The Commission has issued the enclosed Amendments No. 20, 20, and 17 for Licenses No. DPR-38, DPR-47, and DPR-55, for the Oconee Nuclear Station, Units 1, 2, and 3. These amendments consist of changes to the Technical Specifications and are in response to your request dated December 1, 1975, as supplemented February 24 and 27, 1976.

OCONEE NUCLEAR STATION, UNIT 1

Amendment No. 20
License No. DPR-38

ATTACHMENT TO LICENSE AMENDMENTS

FIGURE 2.1-1A

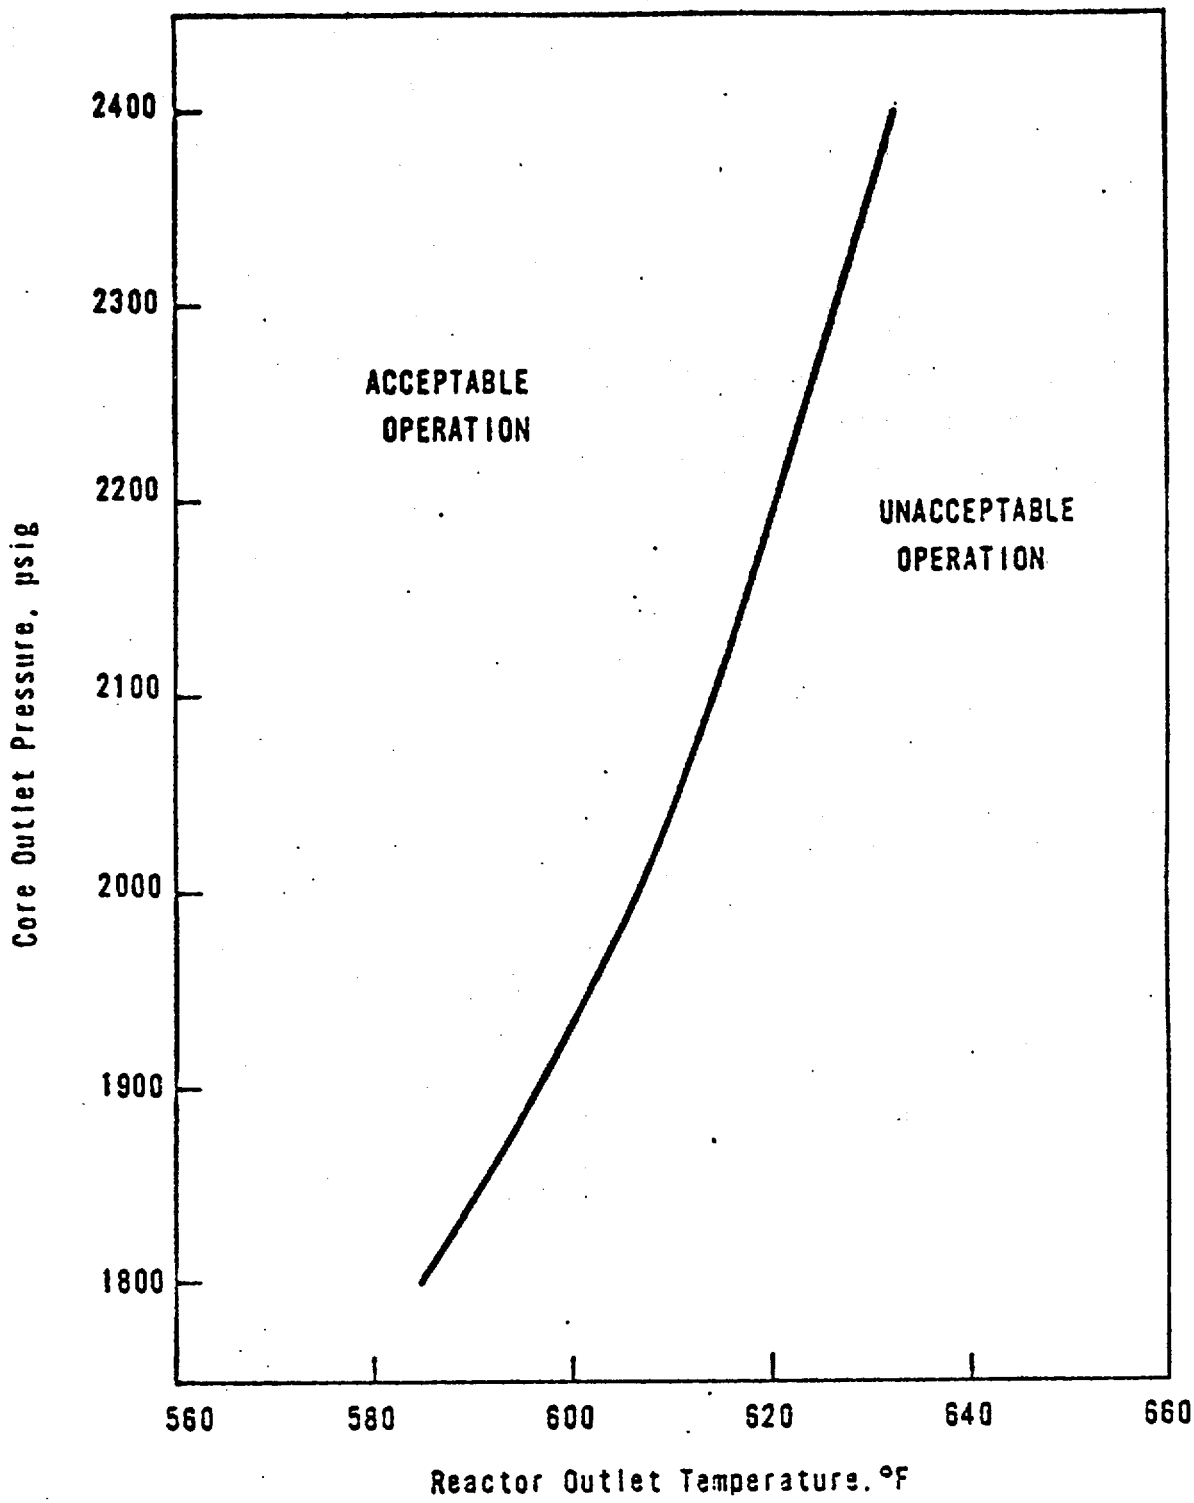
The curve presented in Figure 2.1-1A represents the conditions at which a minimum DNBR of 1.30 is predicted for the maximum possible thermal power (112 percent) when four reactor coolant pumps are operating (minimum reactor coolant flow is 107.6 percent of 131.3 x $10^6$ lbs/hr.). This curve is based on the combination of nuclear power peaking factors, with potential effects of fuel densification and rod bowing, which result in a more conservative DNBR than any other shape that exists during normal operation.

UNIT 1
CORE PROTECTION SAFETY LIMIT
OCONEE NUCLEAR STATION
FIGURE 2.1-2A

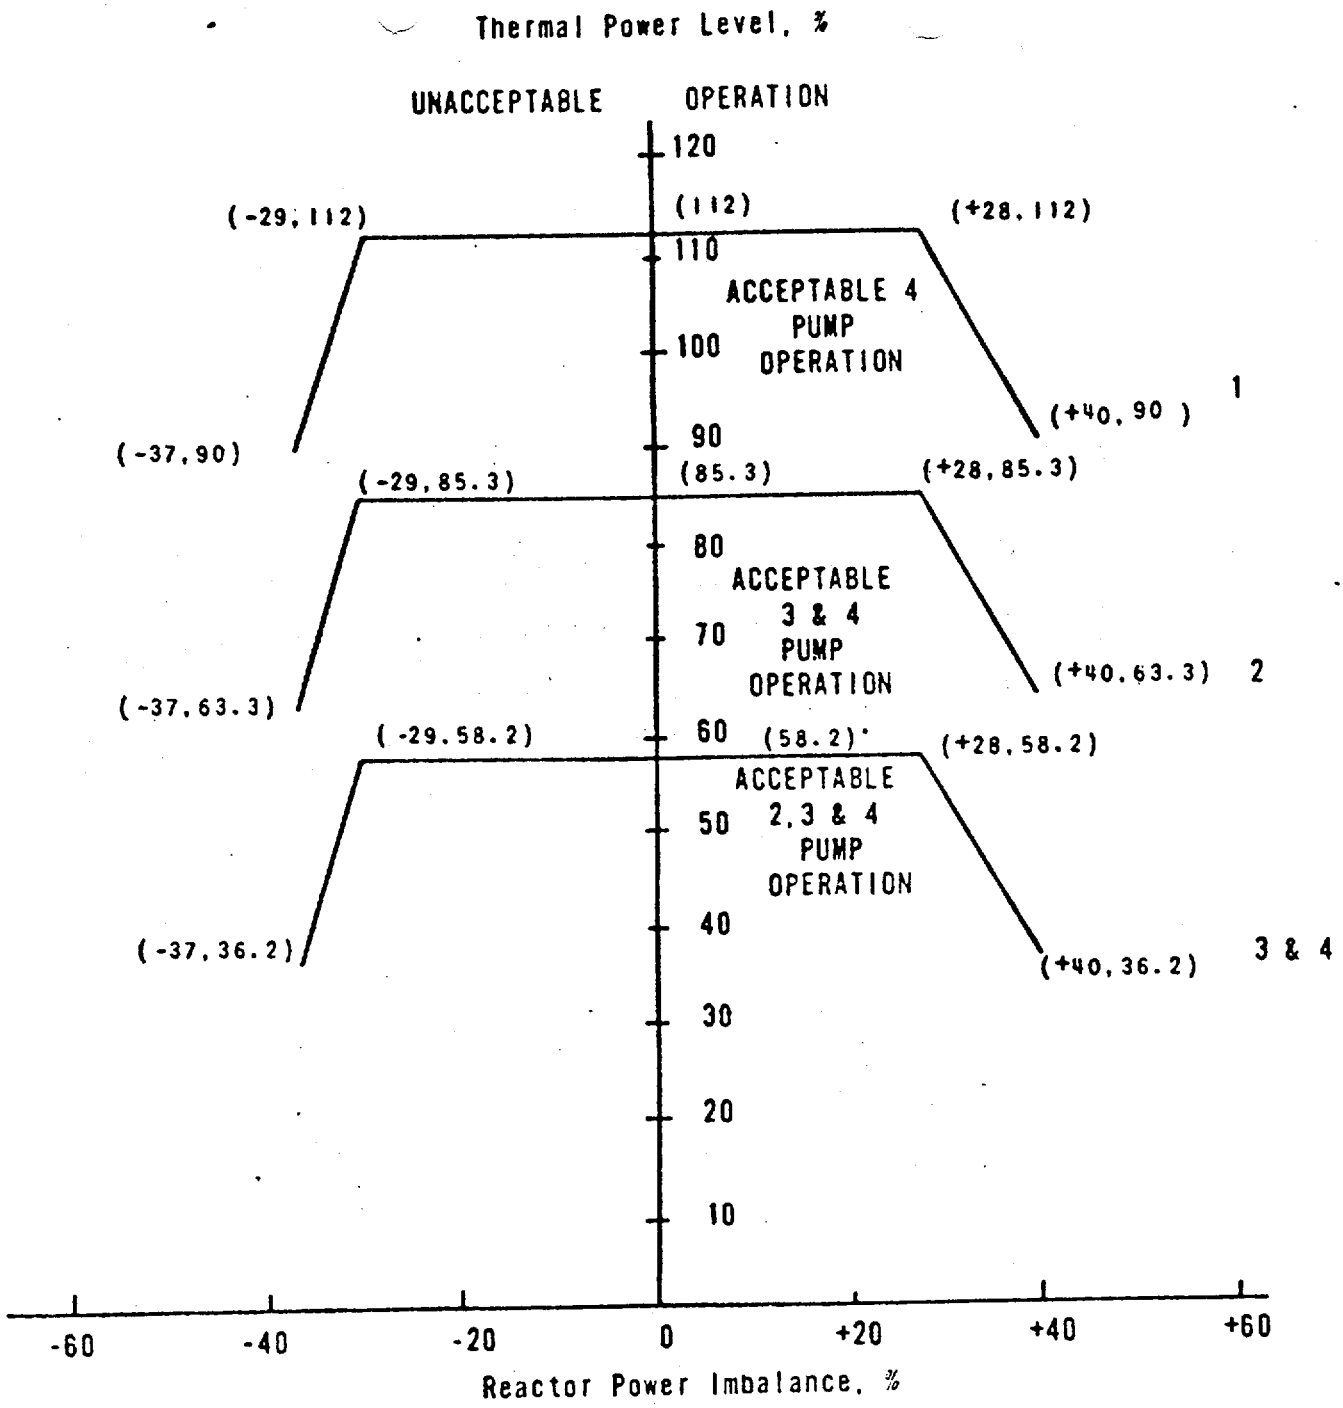
The curves of Figure 2.1-2A are based on the more restrictive of two thermal limits and include the effects of potential fuel densification and rod bowing:

The specified flow rates for Curves 1, 2, 3 and 4 of Figure 2.1-2A correspond to the expected minimum flow rates with four pumps, three pumps, one pump in each loop and two pumps in one loop, respectively.

UNIT 1
OCONEE NUCLEAR STATION
FIGURE 2.1-3A

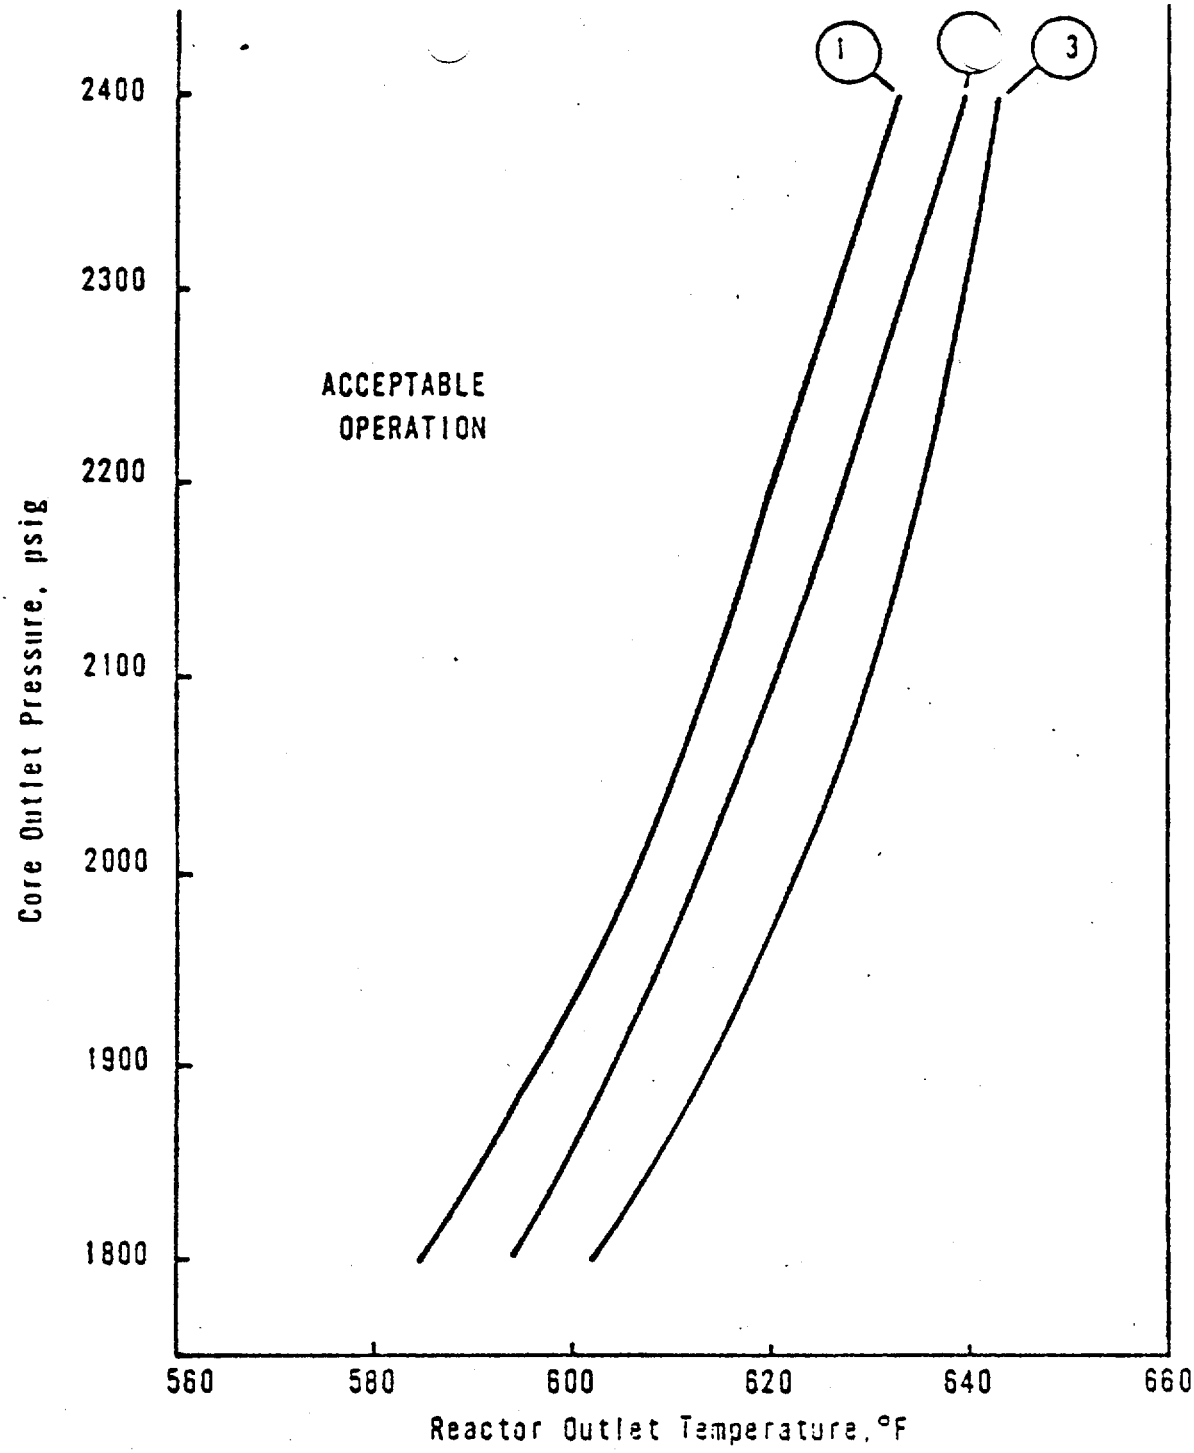
For Figure 2.1-3A, a pressure-temperature point above and to the left of the curve would result in a DNBR greater than 1.30. The 1.30DNBR curve for four-pump operation is more restrictive than any other reactor coolant pump situation because any pressure/temperature point above and to the left of the four pump curve will be above and to the left of the other curves.

UNIT 1
PROTECTIVE SYSTEM MAXIMUM
ALLOWABLE SET POINTS
OCONEE NUCLEAR STATION
FIGURE 2.3-1A

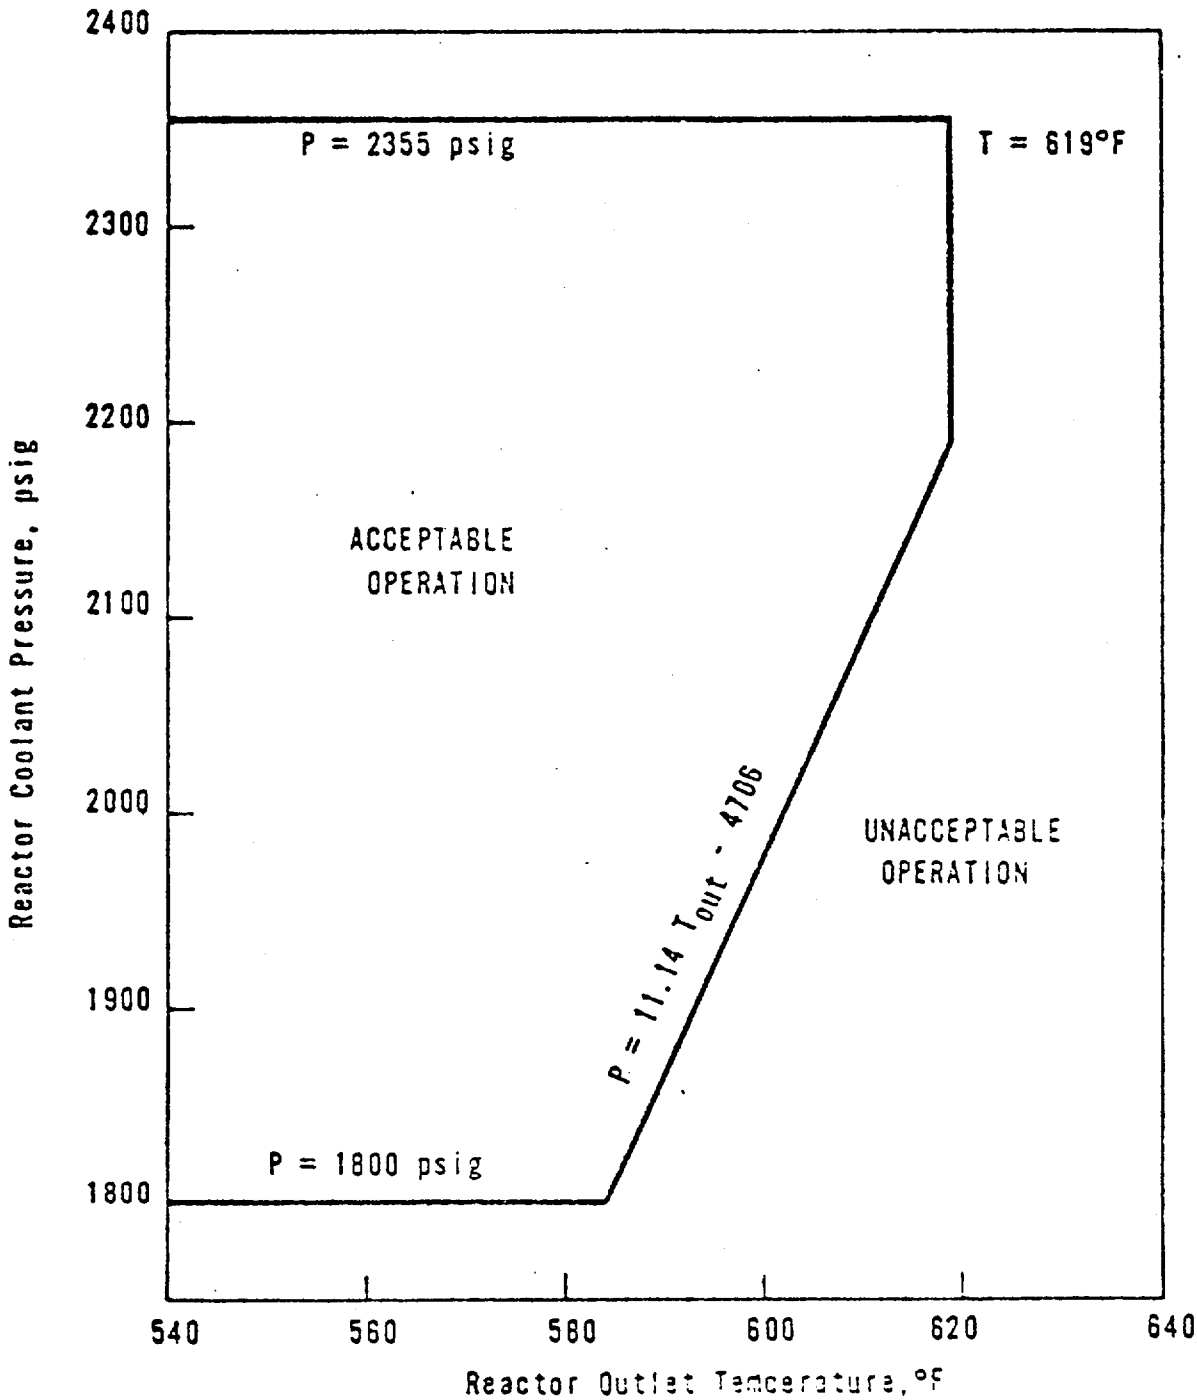
During a startup accident from low power or a slow rod withdrawal from high power, the system high pressure set point is reached before the nuclear overpower trip set point. The trip setting limit shown in Figure 2.3-1A - Unit 1
2.3-1B - Unit 2
2.3-1C - Unit 3
for high reactor coolant system pressure (2355 psig) has been established to maintain the system pressure below the safety limit (2750 psig) for any design transient. (1)

The low pressure (1800) psig and variable low pressure (11.14 $T_{out}$-4706) trip
(1800) psig (16.25 $T_{out}$-7756)
(1800) psig (16.25 $T_{out}$-7756)
setpoints shown in Figure 2.3-1A have been established to maintain the DNB
2.3-1B
2.3-1C
ratio greater than or equal to 1.3 for those design accidents that result in a pressure reduction. (2,3)

The high reactor coolant outlet temperature trip setting limit (619 F) shown in Figure 2.3-1A has been established to prevent excessive core coolant
2.3-1B
2.3-1C
temperatures in the operating range. Due to calibration and instrumentation errors, the safety analysis used a trip set point of 620°F.

FIGURE 2.3-2A

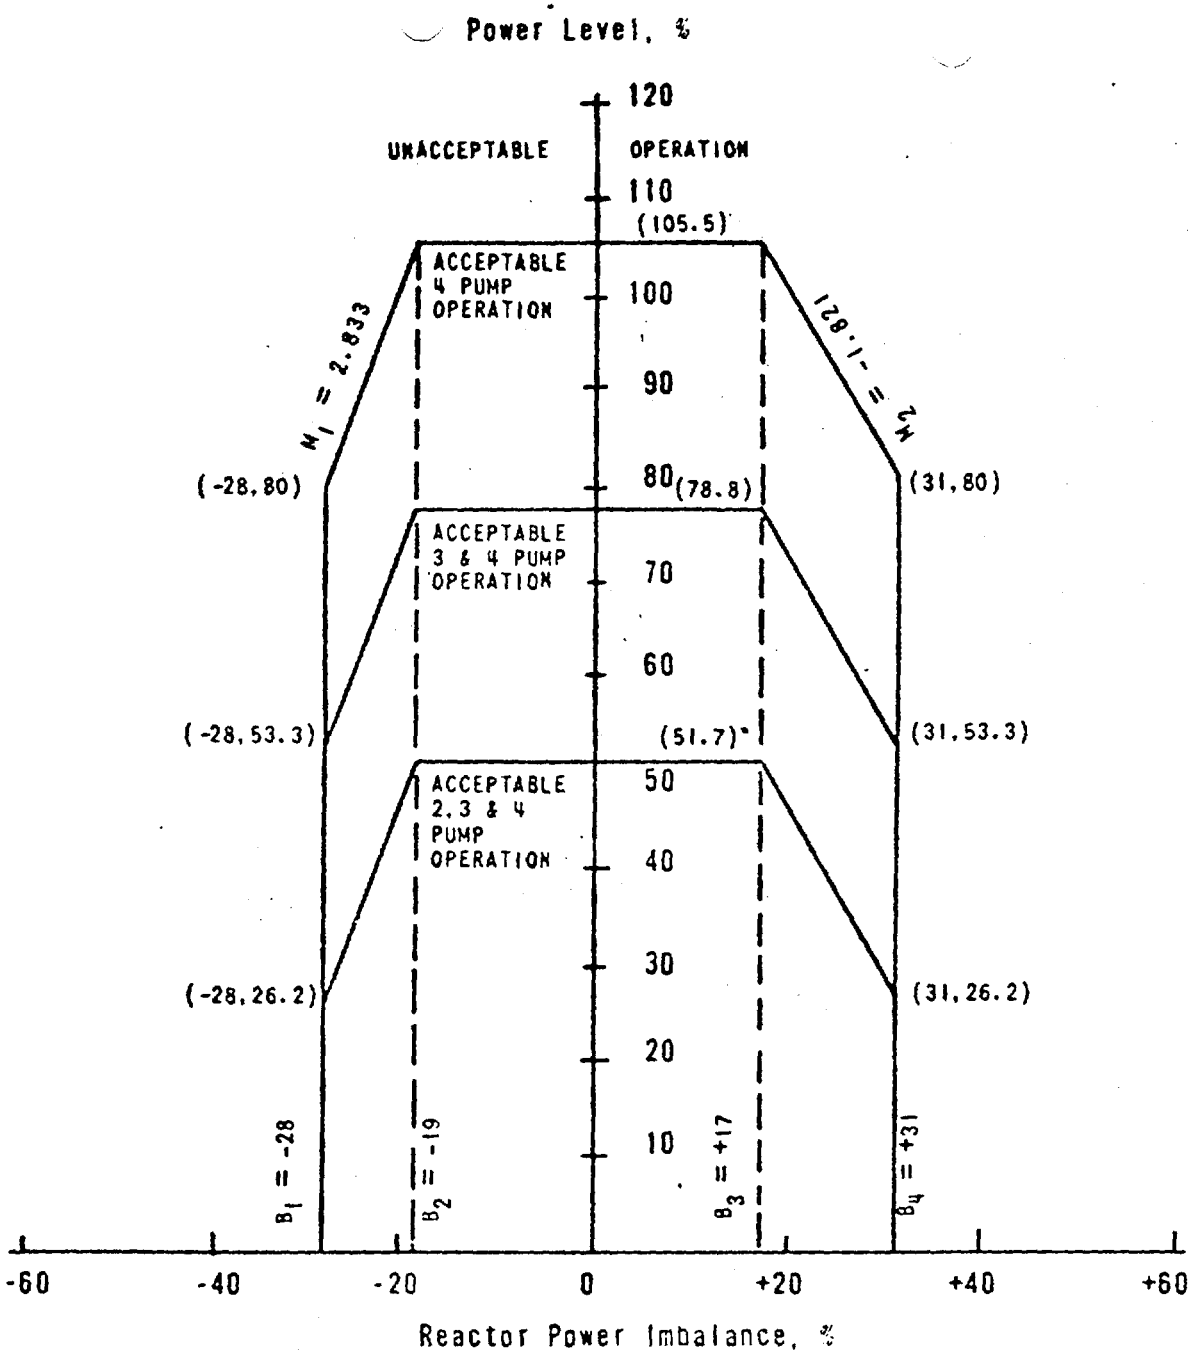
The power-imbalance boundaries are established in order to prevent reactor thermal limits from being exceeded. These thermal limits are either power peaking kw/ft limits or DNBR limits. The reactor power imbalance (power in the top half of core minus power in the bottom half of core) reduces the power level trip produced by the power-to-flow ratio such that the boundaries of Figure 2.3-2A - Unit 1 are produced. The power-to-flow ratio reduces the power

level trip and associated reactor power/reactor power-imbalance boundaries by 1.055%-Unit 1 for a 1% flow reduction.
1.07% - Unit 2
1.07% - Unit 3
For Unit 1, the power-to-flow reduction ratio is 0.949, and for Units 2 and 3, the power-to-flow reduction factor is 0.961 during single loop operation.
